UNITED STATES
NUCLEAR REGULATORY COMMISSION
WASHINGTON, D. C. 20585

SUBJECT: SUMMARY OF MEETING WITH NUMARC - DISCUSSION OF REVISION 1,
PWR CONTAINMENT STRUCTURES LICENSE RENEWAL INDUSTRY REPORT

Figure 3-10. Wall Base Mat Junction of Prestressed Containment
(Source: See Reference 3)

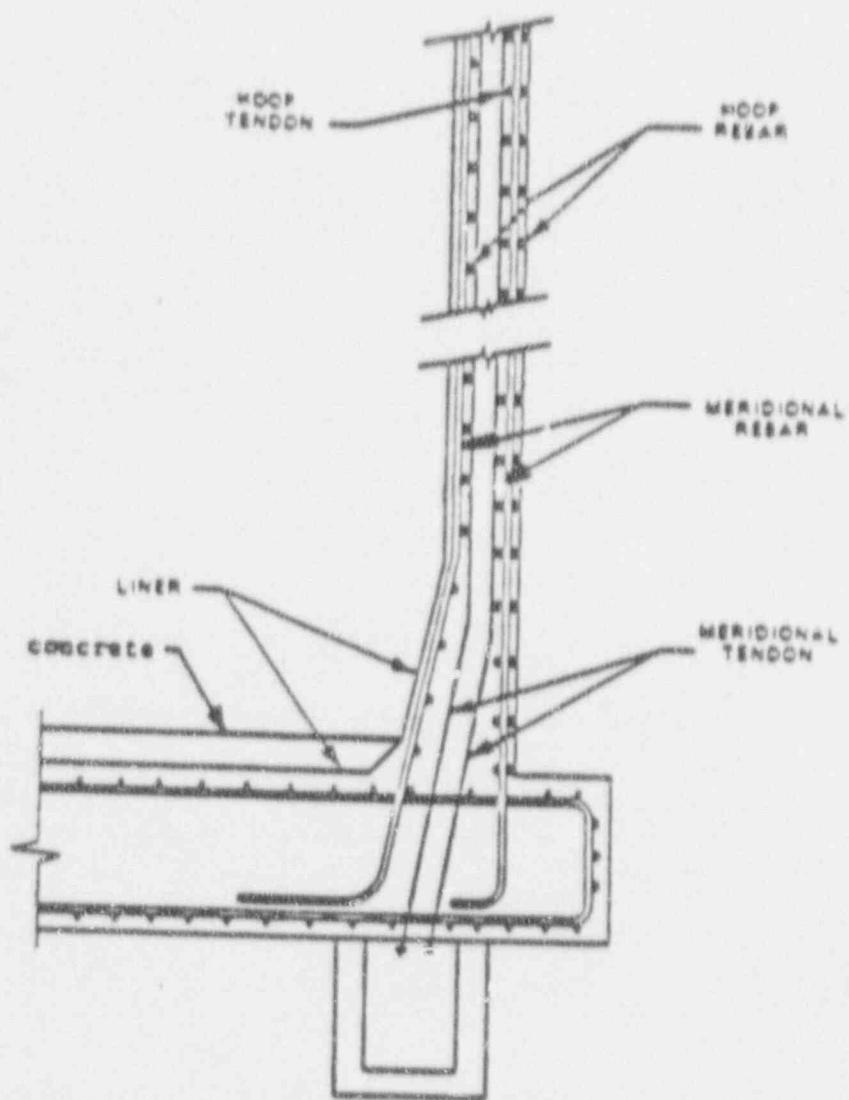
Incorrect statement

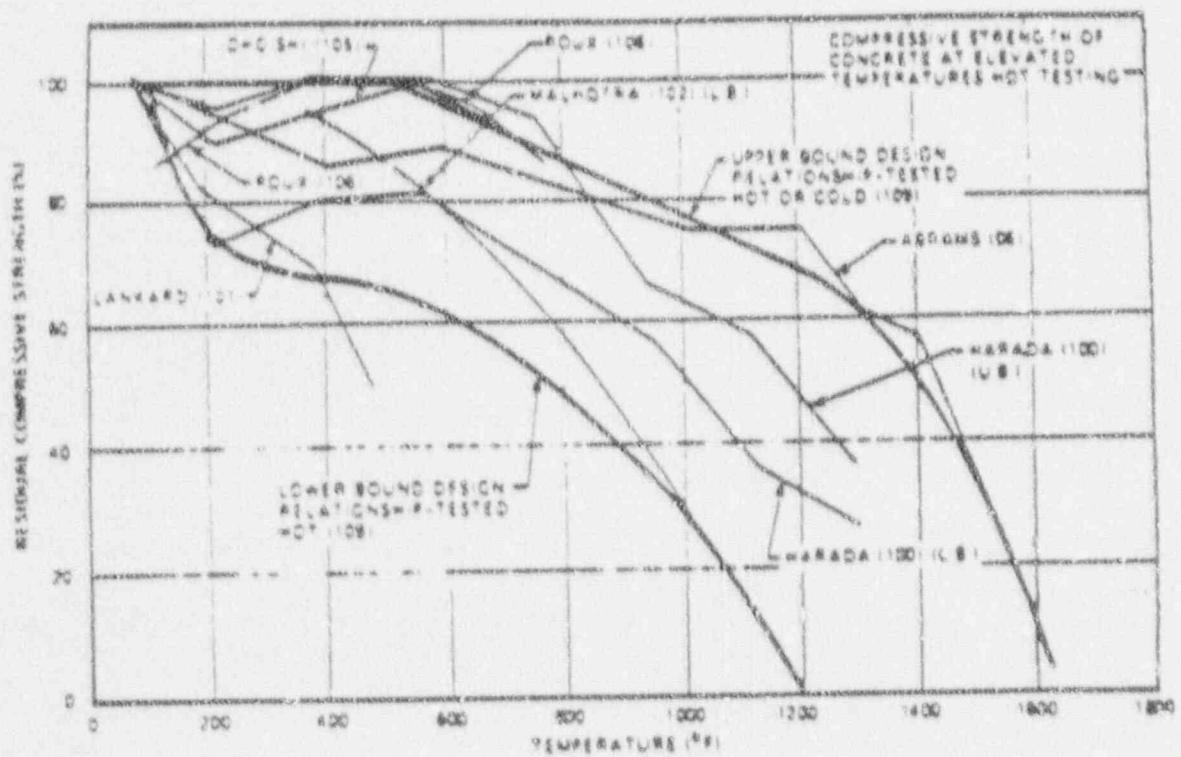
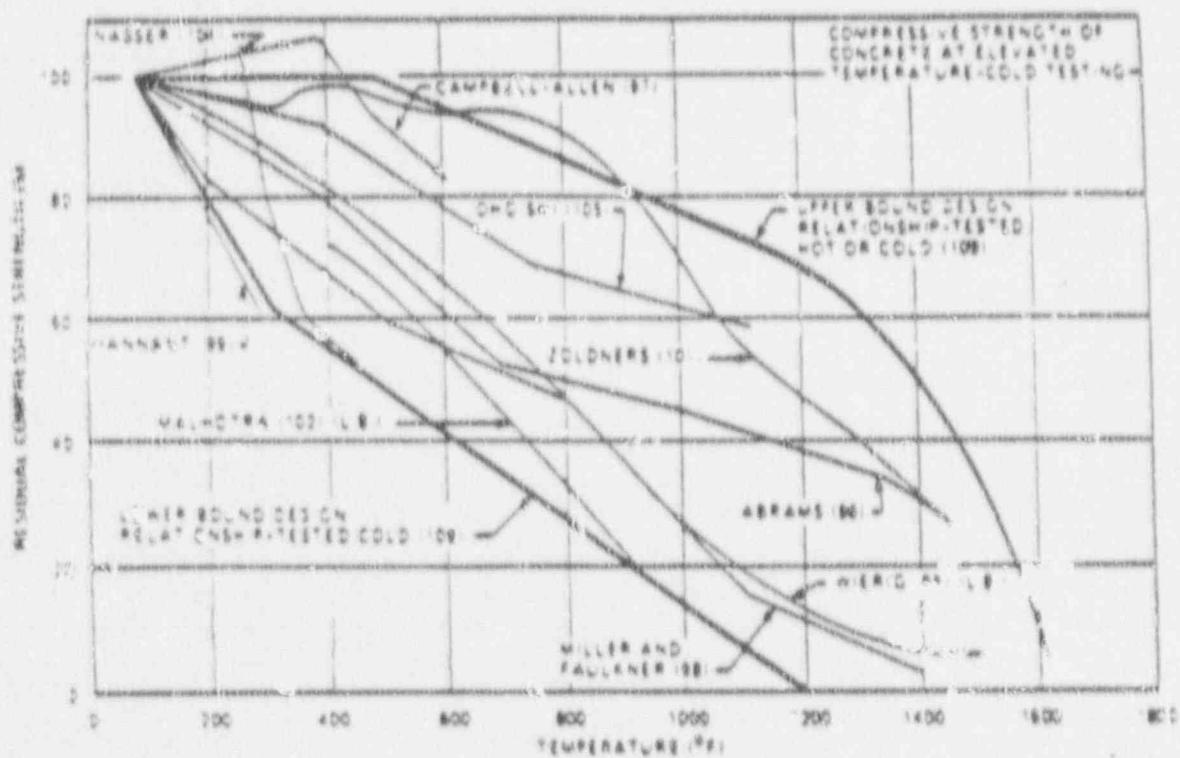
③ Misleading; why not ACI 359?

Figure 4-11. Charpy V-Notch Energy/Temperature Curves for Unirradiated and Irradiated Mild Steel
(Source: See Reference 26)

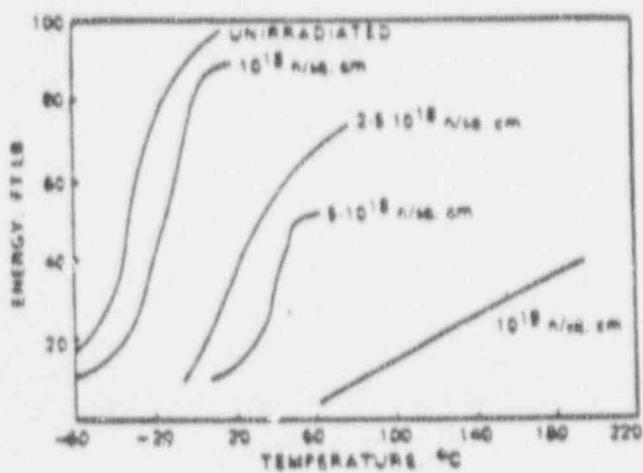
(1) Should discuss microbiologically induced corrosion.
See comment #1, p.3-22.

Figure 4-14
Extremes of Radiation Embrittlement Trends
(Source: See Reference 32)

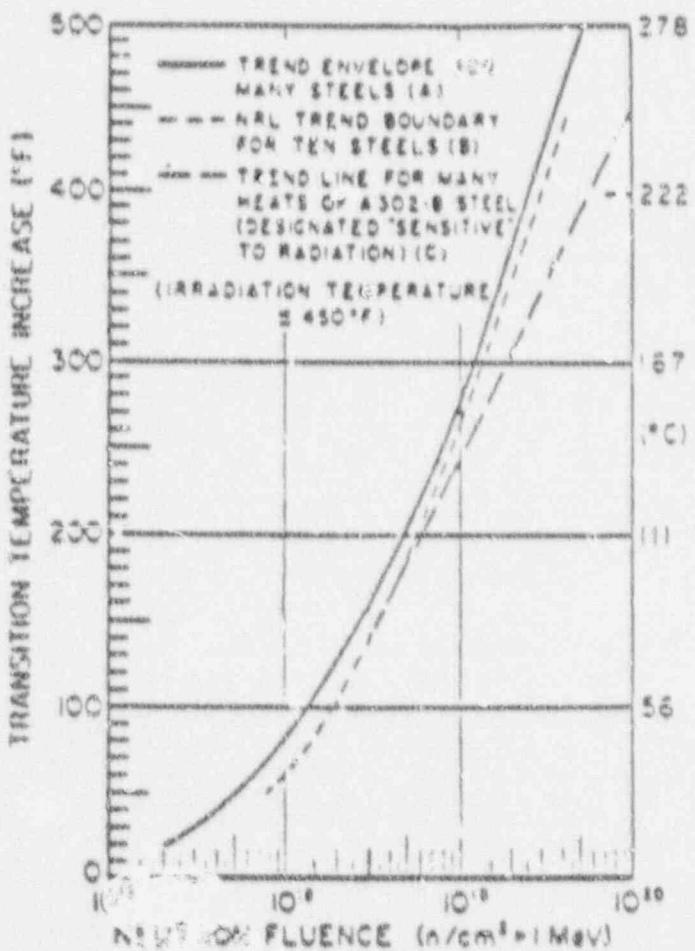
① Use consistent words

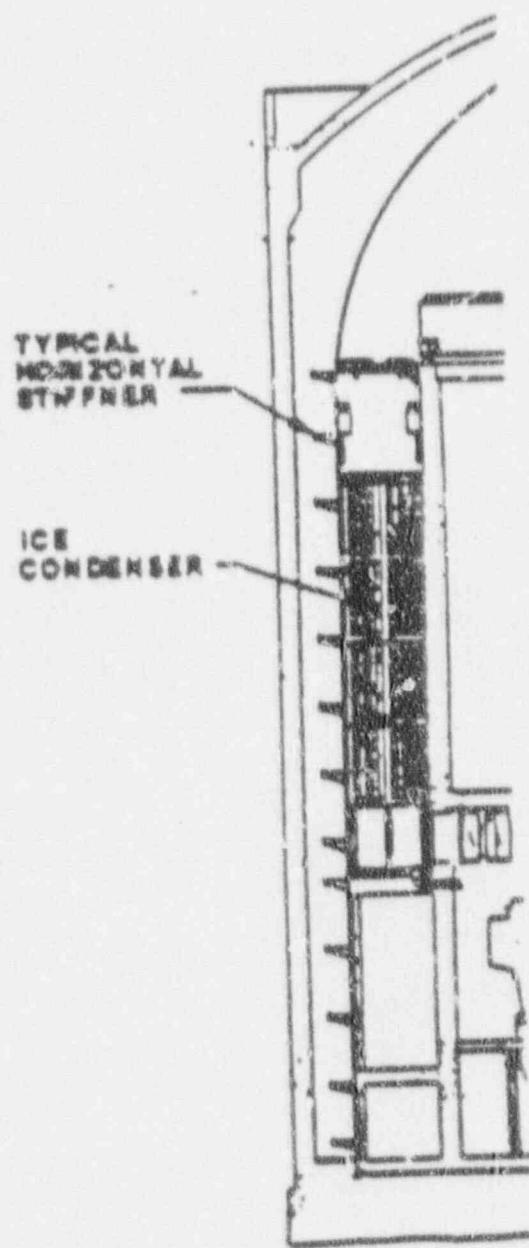
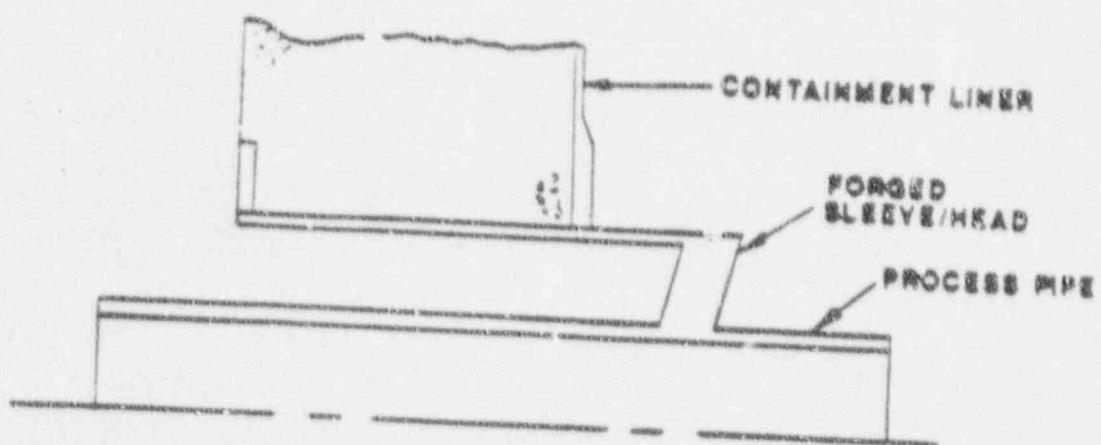
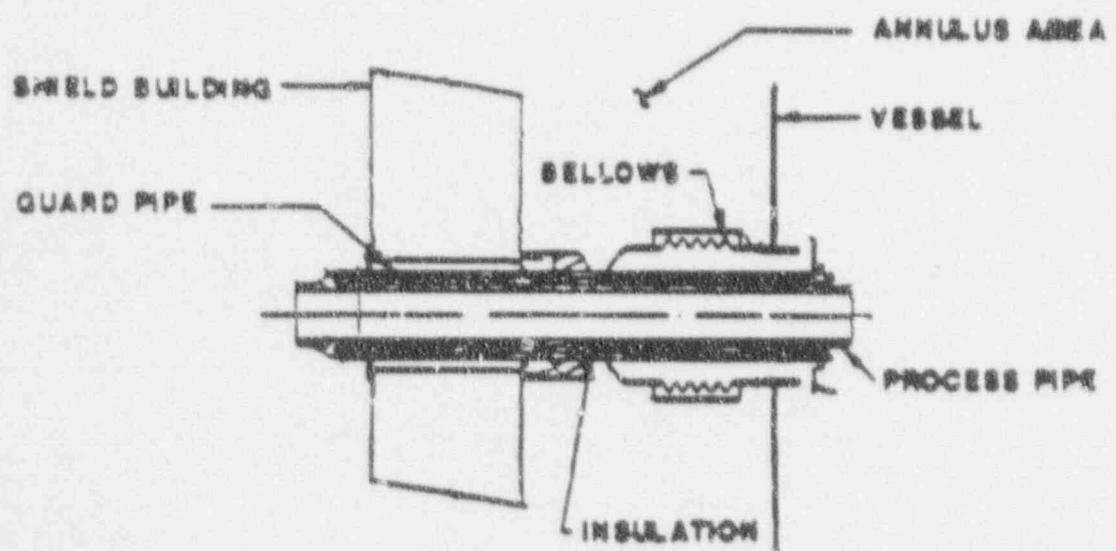
① "Safety function performance" is too limited
